# Building Two Advanced Manufacturing Research Facility

Section 4.55 Modification Report

27 November 2025

**Figure 6 Proposed staging**  
 Source: Architectus (2025)

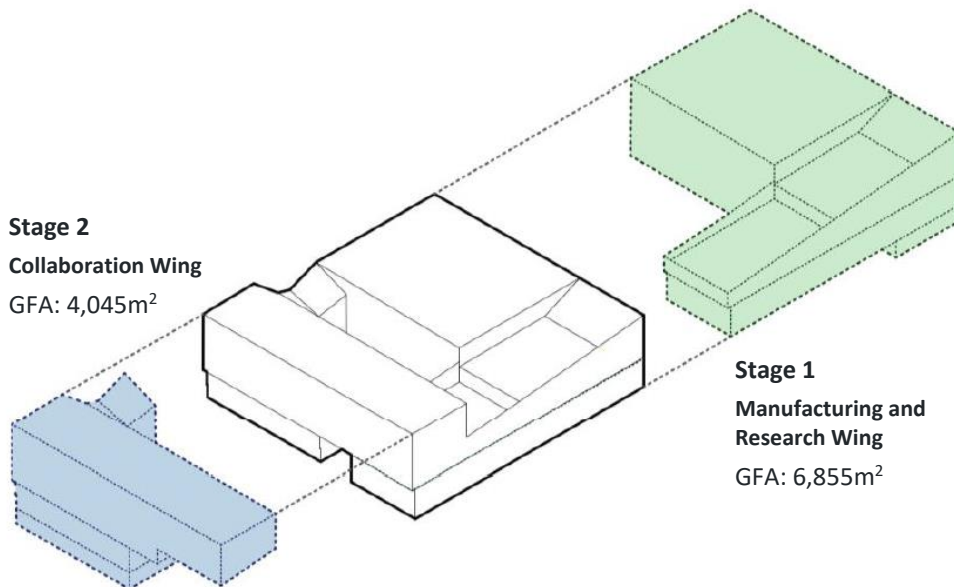
- Removal of Basement Level 2.
- Partial removal of Basement Level 1.
- Deletion of basement car parking and relocation of vehicle loading bay from the basement to the Ground Level accessed from Central Loop West.
- Insertion of additional tenancy space within an interstitial ceiling space on Level 3.
- Partial removal of Level 3.
- Internal reconfiguration including relocation of conference facilities from the Ground Level to upper levels, shifting of advanced manufacturing hall northward and reduction of tenancy space on Level 4.
- Minor building façade changes.
- Rationalisation of landscaping.
- Staged delivery of the development across two stages (refer **Figure 6** and **Table 2**).

The total building GFA has been marginally increased from 10,847m<sup>2</sup> as approved to 10,900m<sup>2</sup>.

**Figure 8 AMRF2 courtyard design as proposed (Stage 2)**  
 Source: Tyrrell Studio (2025)

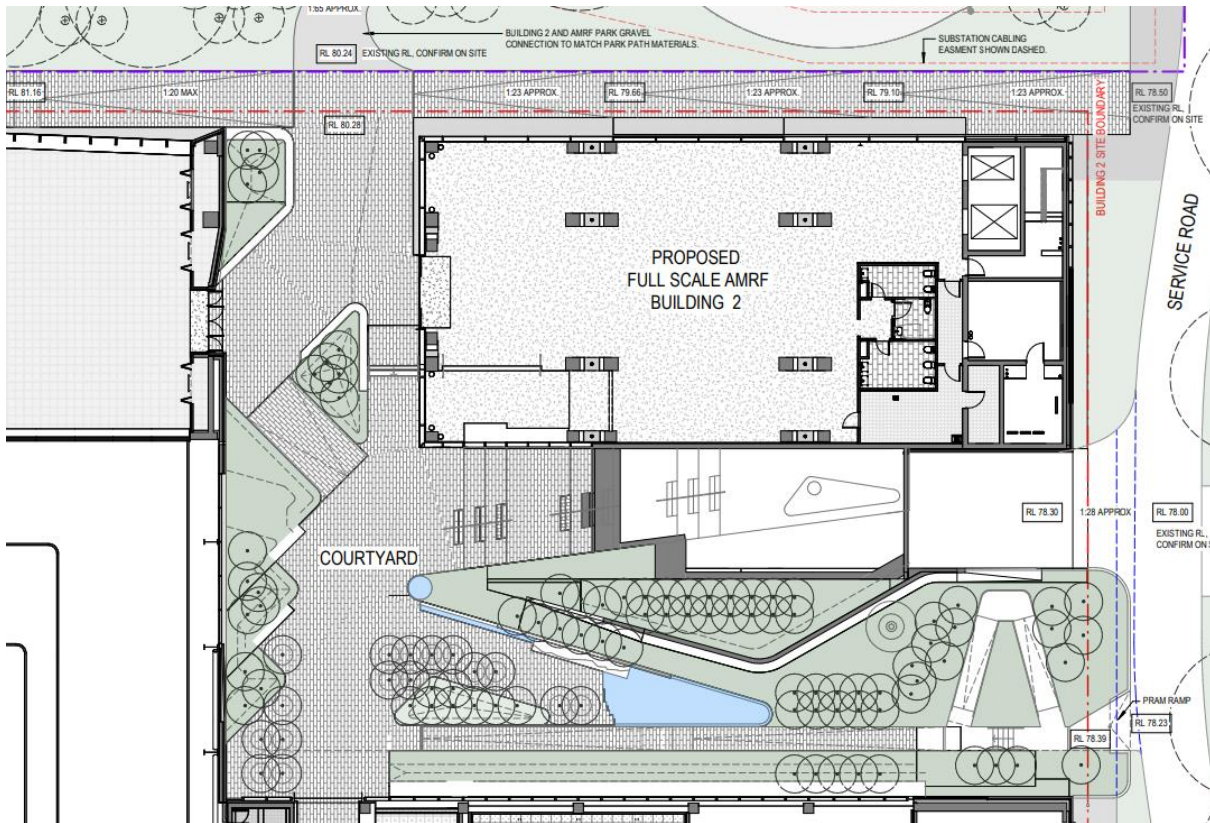
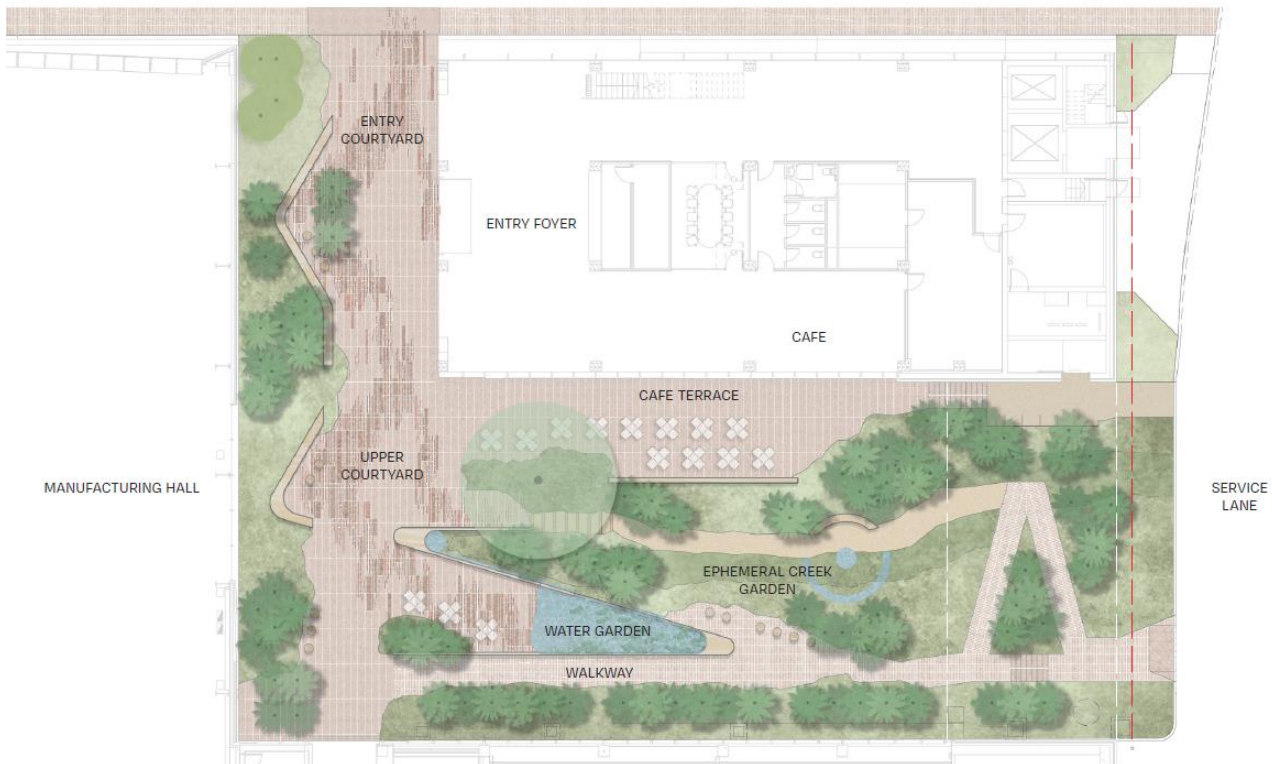
The ultimate (Stage 2) landscape outcome remains largely unchanged from the approved scheme but for the following amendments:

- Stepped terrace at eastern side of courtyard is no longer proposed and is replaced with expanded planting area.
- Conversion of seated terrace into café terrace to provide more formal seating and a stronger physical connection with the foyer space to its north.
- Rationalisation of entry courtyard with larger and contiguous planting area reflecting the removal of a door to the former Conference Hall space.
- Reconfiguration of levels reflective of change to the basement design beneath.

A side-by-side comparison of the two schemes is provided in **Figure 7** and **Figure 8** below.

Figure 9 AMRF2 landscape design as proposed (Stage 1)  
 Source: Tyrrell Studio (2025)

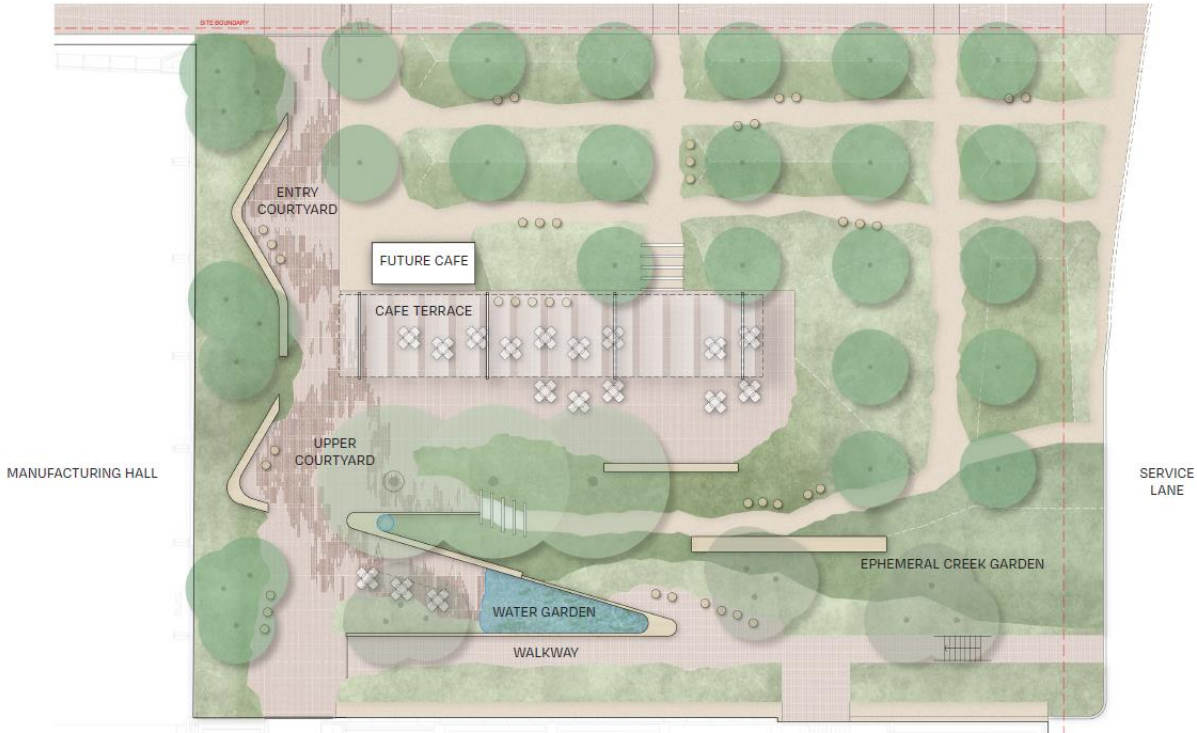
The interim (Stage 1) landscape arrangement provides an appropriate and valuable temporary use of the future Collaboration Wing footprint prior to its construction. The space is proposed to function as a grassland garden with rows of ‘nursery’ trees planted in large tubs set into the ground, enabling them to mature in place and be relocated once Stage 2 commences (see **Figure 9**).
